WESTGATE, KEMPS CREEK (SSD-23480429) | RESPONSE TO REQUEST FOR ADDITIONAL INFORMATION

Table 2 Response to DPHI 06.12.2024 Comments

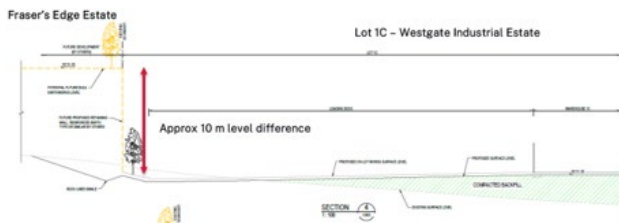
Item	Issue	Response
Traffic		
1	In the event the Aldington Road upgrades are not able to be delivered by others, consider opportunities to include the construction and delivery of the intersection in the DA (as shown in green and pink on the figure below) to enable access to and from the site. If the intersection works are proposed, the DA will need to be amended and will require landowner's consent and an assessment of the impacts associated with the works.  Source: AT&L	The 1,000 series Aldington and Abbotts Road Upgrade works, which includes the ultimate road works and intersection into the site, has been approved under SSD-10479 MOD 3 on 27 February 2025. As such, the Aldington Road upgrades, including the construction and delivery of the intersection, is approved and can be delivered by LOG-NE. The construction and delivery of the intersection does not form part of this SSDA.
2	Further information is required to understand the coordination and delivery of the road connection linking Road 2 with Frasers' North South Access Road. Please provide the following: (a) Details of how the road connection is proposed to be delivered and coordinated between the two parties, including staging / sequencing of works and timing for delivery and dedication to Penrith City Council. (b) Further detail of the levels of the Road 2 / Fraser's North South Access Road connection. Civil Sheet 21-860-C016 shows a	(a) The roadworks on the Edge Estate (Fraser's Property Industrial) and Westgate Kemps Creek (Icon Oceania) will be delivered by the proponents' respective civil works contractors to the property boundary between the two development sites. The need for construction of temporary cul-de-sacs will depend on the relative timing of the civil works. At this stage, given the status of the assessment of the respective SSDAs, it is possible that the roadworks will be delivered concurrently, meaning the temporary turning heads would not be required on either site. However, if for some reason the roadworks on one site are delivered in advance of the other, the extents of roadworks delivered first will need to incorporate the temporary turning head. Depending on

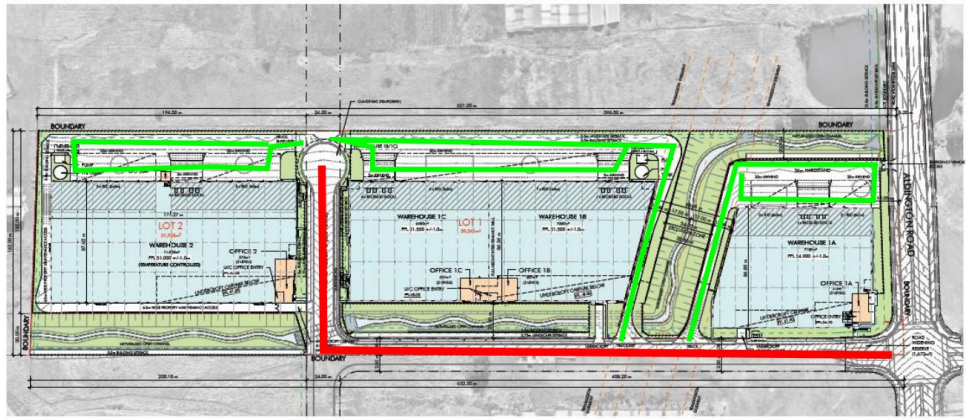
6	Provide the noise contribution levels for the following noise generating activities: heavy vehicle movements, loading and unloading activities, general rooftop plant equipment and specialised equipment. This is to allow the Department to understand specific risks or opportunities for further targeted mitigation.	Applicant Response 16.01.2025 <i>The assessment as part of the NIVA has already demonstrated compliance with project noise goals so further noise mitigation is not warranted under the procedures of the NPfl.</i> <i>A review of the relative contributions to the potentially highest noise levels predicted at R11 and R17 in Mt Vernon. The results confirmed that the highest noise contributor from</i>

Item	Issue	Response
		<i>the Westgate site is typically truck movements followed by WH2 chiller room and condensers.</i> <i>With regard to heavy vehicle movements, additional mitigation measures are not feasible considering roadways and elevated receivers. Also, Road 1 (adjacent southern side of WH1a and WH1b/c) and Road 2 (running north between WH1b/c and WH2) will ultimately become public roads and thus, would ultimately be excluded from 'site noise emissions' and be considered traffic on public road under the NSW Road Noise Policy, with a higher noise criteria.</i> <i>With regard to the WH2 chillers and condensers, additional noise mitigation measures in the form of a 5dB reduction of from noise emissions and was reviewed and confirmed a cumulative noise level drop of 0.5dB at highest predicted location at Mt Vernon (R17). This level of reduction is minimal and provides imperceptible acoustic benefit. These measures would result in reductions at R11 of 1.8dB but this is isolated and cumulative noise for the whole Mt Vernon will typically change very little.</i> <i>With consideration of the above, a review individual contributions from each source is beyond the typical scope of what is provided within a SSDA or DA assessment.</i> <u>DPHI Response 21.01.2025</u> <i>Noise generation modelling should reflect worst case scenario for loading docks, reflecting the docks being close-to or at-capacity. We need to ensure this is as realistic as possible and reflects worse case operational scenarios</i> <u>Applicant Response 03.02.2025</u> <i>Noise modelling has considered the anticipated worst case for the day, evening and night assessment periods. As outlined in Section 4.2.2 Page 32 of the NVIA v4 the assessment considered the PEAK 1hr truck movements within each assessment period and then considered that number broken down into a relative 15-minute assessment period as required. The context of the NVIA also confirms that truck movements outside of these peak periods are significantly lower. The assessment has also considered a full changeover of carpark for light vehicles, continuous use of fork trucks external and continuous operation of the specified mechanical plant.</i> <u>DPHI Response / Heavy Vehicle Movement 04.02.2025</u>

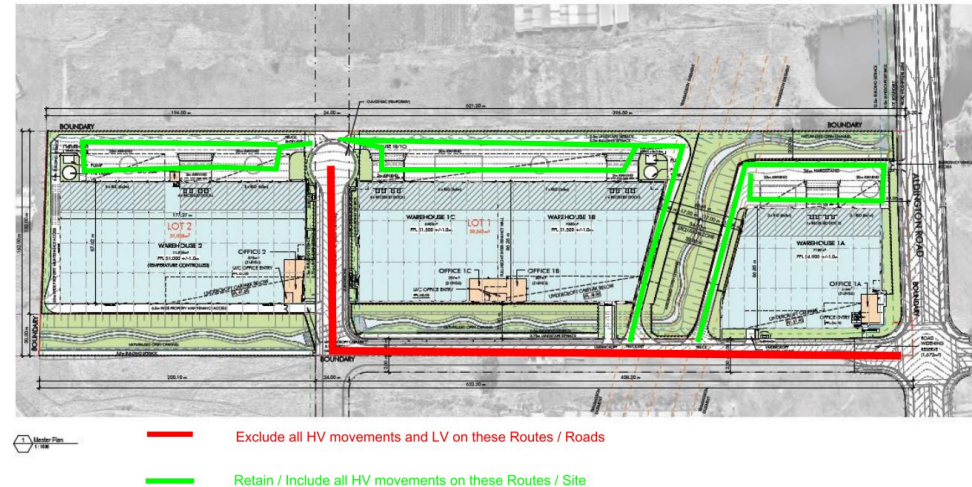
8	Provide justification for the heavy vehicle numbers adopted in Table 4.6 and clarify what benchmark sites were used in the Traffic Impact Assessment to determine the heavy vehicle numbers in Table 4.6. Please note the GTIA provides trip generation profiles for several reference sites for large format and retail facilities that may be more appropriate for use as benchmark sites for this assessment.	<u>Applicant Response 16.01.2025</u> <i>Section 4.2.2 of the confirms based on the Ason TIA that the following peak hourly HV numbers are projected per period: 23 Day, 8 Evening and 15 Night. From these values Table 4.6 presents the anticipated distribution of those total numbers per period for a 15 minute typical worst case assessment as outlined in text on Page 32 of NVIA.</i> <u>DPHI Response 21.01.2025</u>

Item	Issue	Response
		Noise generation modelling should reflect worst case scenario for loading docks, reflecting the docks being close-to or at-capacity. We need to ensure this is as realistic as possible and reflects worse case operational scenarios <u>Applicant Response 03.02.2025</u> Noise modelling has considered the anticipated worst case for the day, evening and night assessment periods. As outlined in Section 4.2.2 Page 32 of the NVIA v4 the assessment considered the PEAK 1hr truck movements within each assessment period and then considered that number broken down into a relative 15-minute assessment period as required. The context of the NVIA also confirms that truck movements outside of these peak periods are significantly lower. The assessment has also considered a full changeover of carpark for light vehicles, continuous use of fork trucks external and continuous operation of the specified mechanical plant. <u>DPHI Response / Heavy Vehicle Movement 04.02.2025</u> The noise modelling shows the main contributor to noise is heavy vehicle movements. Please present a scenario that excludes heavy vehicle noise sources on public roads to confirm compliance with the project amenity noise levels and for deriving achievable night-time noise limits (eg. with truck movement sources = 31dBA at Mount Vernon, without truck movement sources= 27dBA). <u>DPHI Response / Light Vehicle Movement 04.02.2025</u> Review the assumption for the usage of car park at night to give us a more realistic set of noise predictions. The model currently assumes that the car park is fully utilised at night, which may not be realistic (e.g. without truck movement and car park sources = 26 dBA). <u>Applicant Response / Heavy Vehicle Movement 07.02.2025</u> Please find a mark-up site plan which identifies the heavy vehicle movements across the estate roads (in red, to be excluded in modelling scenario) and heavy vehicle movements across the warehouse driveways and loading dock/hardstand areas (in green, to be included in modelling scenario). Can you please confirm that this would satisfy the scenario modelling you have requested and EMM will update the NVIA accordingly.

Applicant Response / Light Vehicle Movement | 07.02.2025

EMM have modelled the scenario where there is no use of the carpark and light vehicles at night. This scenario modelling found that no carpark and light vehicle use at night this results in a reduction of <0.1dB. This saving is considered to result in negligible impact. In the instance there is partial use of the carpark and light vehicles at night (e.g. 50% utilization), the acoustic saving will be even less.

Yes this is fine. Please update NVIA

Noted. No need to update modelling assumptions.

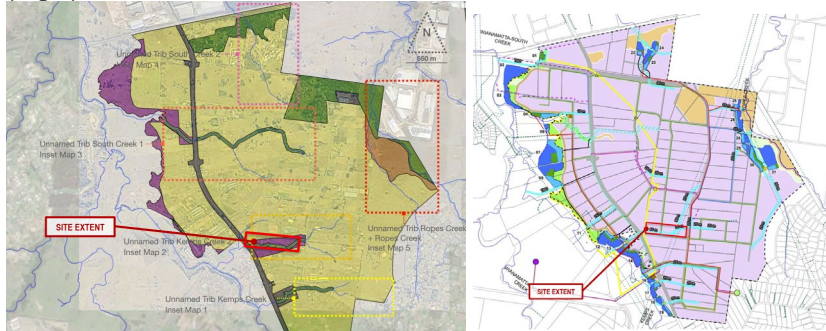
Civil Plans		
10	The Submissions Report notes that a two-tier wall system has been proposed on the Frasers/Icon Oceania interface, yet the civil plans 21-860-C015 and 21-860-C016 only show tiered retaining walls at one portion of the common boundary. Please amend the plans to show the two-tier system along the Frasers / Icon interface.	Sections 3 and 4 shown on drawings 21-860-C015 and C016 respectively show the interface between proposed Lots 1B/1C and The Edge Estate to the north being a cut batter and rock lined swale within The Edge Estate. Retaining walls within The Edge Estate are shown within the civil works package that is current under assessment under SSD-17552047. It is noted that there will be two walls due to the proposed driveway that will provide access to Lot 14 from Road 02 within Edge Estate. The proposed wall directly adjacent to the boundary between Edge Estate and Westgate Kemps Creek will be up to 5.2 metres high, and given the location of this wall is not adjacent to the public domain or a public road it is not proposed that this wall would be tiered.

Item	Issue	Response
		Refer to drawing 20-776-C1006 and C1015 from SSD-17552047 that shows the proposed Fraser wall steps on this boundary.
Water		
11	The Department notes a Strahler order 2 waterway is identified on-site. Please demonstrate consistency with Section 2.3 of the MRP DCP in relation to the ongoing management and maintenance of riparian land.	As per the <i>Mamre Road Precinct Waterway Assessment</i> (CTEnvironmental, April 2020), contained in the <i>Mamre Road Flood, Riparian Corridor, and Integrated Water Cycle Management Strategy</i> (Sydney Water, October 2020), the mapping shows a Strahler order 2 waterway running through the site. Subsequently, the MRP DCP and Sydney Water identified indicative locations of trunk drainage infrastructure, which includes a trunk drainage corridor that runs along the same, general location as the Strahler order 2 waterway (refer to the below). Extract of waterway mapping (Left) and Mamre Road Precinct Stormwater Scheme Plan (Right)  As part of this project, a trunk drainage channel is proposed to form part of the broader water management strategy within the Mamre Road Precinct. This trunk drainage channel is approved in principle by Sydney Water. As such, while the development will not maintain the Strahler Order 2 waterway in its natural state, as per Section 2.3 of the MRP DCP, the development seeks to achieve the relevant water quality and flow-related objectives in collaboration with Sydney Water, and consistent with the general alignment for a trunk drainage channel, as identified in the MRP DCP. Consistent with Sydney Water's Stormwater Scheme Plan (May 2024), the

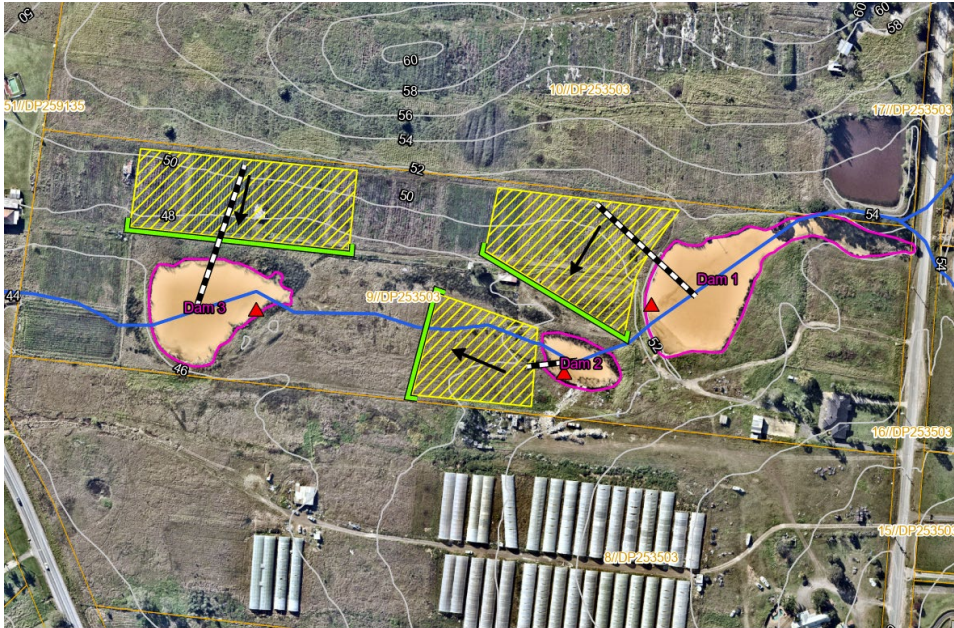
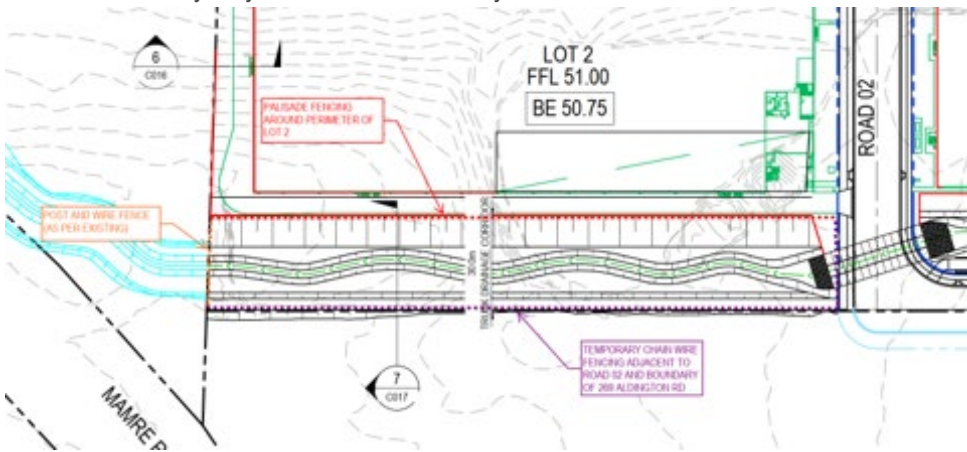
Item	Issue	Response
		proposed development of Westgate Kemps Creek will incorporate a naturalised trunk drainage channel, for which design development has been undertaken with Sydney Water to reach a mutually agreeable corridor width, which varies between 20 metres and 32 metres throughout the site. A dam dewatering plan (Appendix C) and dam dewatering report (Appendix D) has been prepared to ensure that the existing fauna and flora is appropriately managed and processed to minimize any potential impacts. This includes details of how aquatic fauna will be rescued and relocated of engagement. A Biodiversity Assessment Report was prepared, which includes an assessment of the native vegetation surrounding the existing farm dams and identifying mitigation measures to ensure the development results in an acceptable ecological outcome. Scape Design has prepared a Landscape Masterplan and Planting Plan for the naturalised trunk drainage corridor (Appendix I of the November 2024 Submissions Report). As seen in the image below, the bulk of the waterway, outside of the farm dams, are comprised of cleared grasslands. As such, the proposal aligns with the objectives of Section 2.3 of the MRP DCP.

Item	Issue	Response
		 ▲ Water quality sample point ➔ Direction of slope — Recommended erosion control — Recommended pump position — 1:25,000 waterway mapping (DCCEE Water Group) — Contours (2 m) □ Dam ▨ Recommended irrigation area □ Cadastral ■ Key Fish Habitat (DPI Fisheries)

Item	Issue	Response
12	Provide additional commentary to support the modelling results outlined in section 8.2 and 8.3 of the Updated Water and Stormwater Management Plan (Appendix X of the Submissions Report) describing how the proposed stormwater management strategy complies with the Technical Guidelines for Achieving Wianamatta South Creek Stormwater Management Targets and relevant provisions of the MRP DCP.	The proposed interim arrangement of stormwater management measures that are presented on drawing 21-860-C250 will ensure the proposed development of Lots 1A, 1B and 1C will comply with the stormwater quality and flow volume targets stipulated in Section 2.4 of the Mamre Road Precinct DCP. Once the Sydney Water regional scheme infrastructure that will service Westgate Kemps Creek is completed and ready to be connected to, the interim measures within Westgate Kemps Creek will be decommissioned.

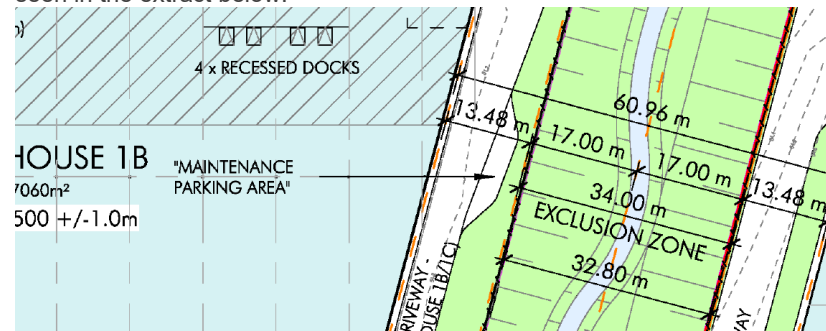
15	Update the architectural plans to show the proposed parking pad that would provide access to the Transgrid easement.	The architectural plans have been updated to show the "maintenance parking area" located adjacent to the Warehouse 1B/1C driveway and riparian corridor (Appendix F) as seen in the extract below.
----	--	---

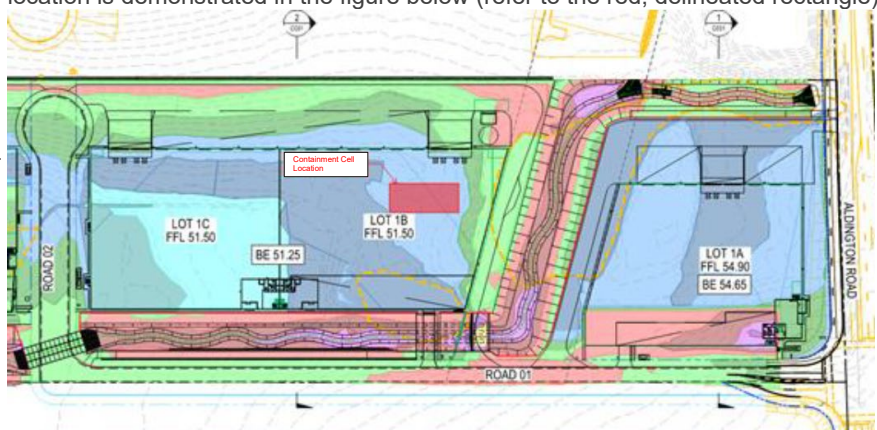
4b	Use of Bakers Lane by development traffic should be prohibited.	Noted: use of Bakers Lane by development traffic is not proposed as part of this SSDA.
4c	Operation of the site shall not commence until the road upgrades are delivered.	It is agreed that the suitable conditions stipulating that site intersection upgrades must be completed in accordance with 1,000 Series, SSD-10479-Mod 3, prior to any Occupation Certificate being issued.
4d	Swept path assessment provided by Ason Group show heavy vehicles would be required to cross the centre of the road to make turns.	Response to the half road construction have been subject to separate discussions with DPHI & Council and are understood to be resolved.
5ai	A revised Remediation Action Plan has now been prepared, and it is considerably more detailed than the previous version of the document. A 'cap and contain' strategy has still been put forward as a potential remediation strategy for addressing asbestos impacted materials, but the document includes significantly more information regarding all the identified areas of environmental concern.	Noted, an updated Remediation Action Plan (RAP) (Appendix B) has been prepared to respond to the comments below. Additionally, an Interim Audit Advice Letter has been prepared by the site auditor, Ramboll (Appendix Q), which confirms that the Rap methodology is supported.

Item	Issue	Response
5aii	In addition to the above, the Submissions Report has also now acknowledged that the remediation works will occur prior to bulk earthworks commencing, however it has also been identified that they may need to be staged to align with other works on site. Whilst this approach is supported by Council, it needs to be ensured that where it is proposed to remediate using the containment cell, that the construction of the cell has not been completed when it may still need to be utilised in other stages to address contaminated materials.	The Remediation Action Plan (Appendix B) has been updated and recommends the containment cell is open until remediation works utilizing the cell are completed. The containment cell location has been coordinated with team and the potential containment cell location is demonstrated in the figure below (refer to the red, delineated rectangle).

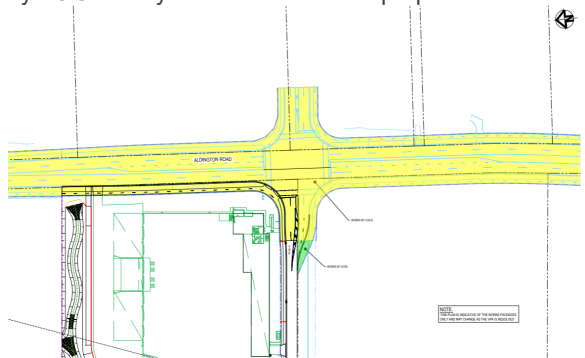
Item	Issue	Response
1	Inconsistency between engineering plans (Appendix W - Updated Civil Drawings) and the LOGNE 3000 Series plans (works proposed to be delivered by LOGNE). The engineering plans show the ultimate road works along the frontage of the adjoining lot to the south are to be coordinated by the LOGNE group (refer to purple shaded area in the extract below), however the 3000 series of plans do not include the road works along the frontage of the adjoining lot to the south. The development will be required to deliver the roadworks along their frontage (green shaded area - 1000 Series drawings) and the frontage of the lot to the south including the partial delivery of the western leg of the signalised intersection (purple shaded area), to enable the safe and efficient operation of the western leg of the signalised intersection. It is also noted the area highlighted yellow in the extract from the engineering plans (Appendix W) differs from the 3000 series plans	Refer to the updated "Owner Works Plan" (21-860-C603) in the subdivision works drawing package at Appendix P. An extract is provided below. This clarifies the works to be delivered by LOGNE in yellow and has been prepared to be consistent LOGNE 3,000 Series plans.

Item	Issue	Response
	(extract of 3000 series plans shown below). The area highlighted yellow includes 2 lanes in each direction and dedicated right turn lanes - the 3000 Series only propose 1 lane in each direction within the vicinity of the site. The development will be required to also deliver part of the yellow shaded area in accordance with the 1000 Series drawings, for the areas that will not be delivered by LOGNE as proposed by the 3000 Series drawings.	
2	The internal 90 degree bend in the half road of where the road turns north, shall be designed to ensure that upon delivery of the full width road, concurrent B-Double vehicles are able to safely pass each other on the bend without encroaching over the ultimate centreline. Turn paths are to be provided demonstrating compliance.	Refer to the "Vehicle Turn Paths Plan Sheet 2" (21-860-C502) at Appendix P which shows the internal 90 degree bend upon full delivery of the full width road can accommodate concurrent B-Double vehicles will not overlap. Noting that the kerb return radius is 15m per the DCP.
